South Texas Project Electric Generating Station
Units 1 and 2
Docket Nos. STN 50-498, STN 50-499
Emergency Plan Revision 6

In response to comments from NRC personnel, Houston Lighting & Power Company (HL&P) is submitting the attached advance copy of revisions to the South Texas Project Electric Generating Station Emergency Plan. These revisions will be submitted as part of a formal revision to the plan by October 9, 1987.

Attachment: Advance Copy of Emergency Plan Revision 6

SOUTH TEXAS PROJECT ELECTRIC GENERATING STATION EMERGENCY PLAN NORMAL PLANT ORGANIZATION

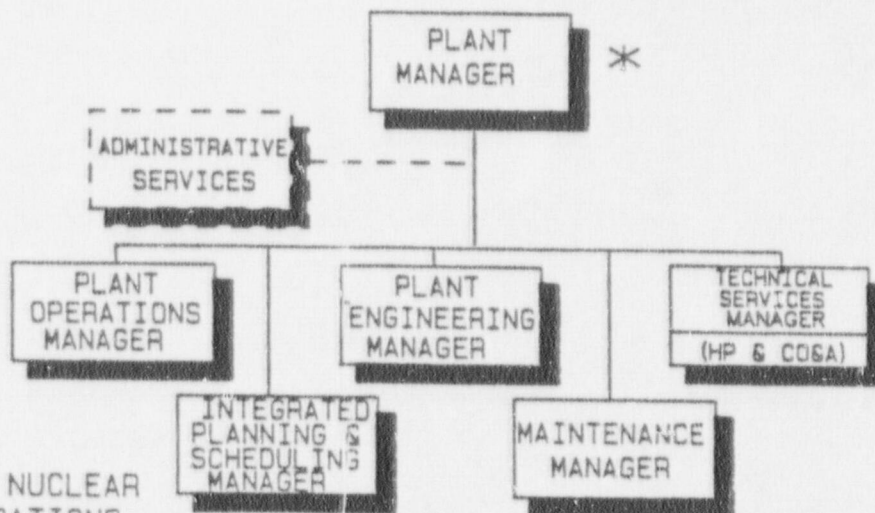
ONLY POSITIONS RELATING
TO EMERGENCY RESPONSE
THAT REPORT TO THE GROUP
VICE PRESIDENT, NUCLEAR
ARE SHOWN

* DETAIL OF NUCLEAR
PLANT OPERATIONS
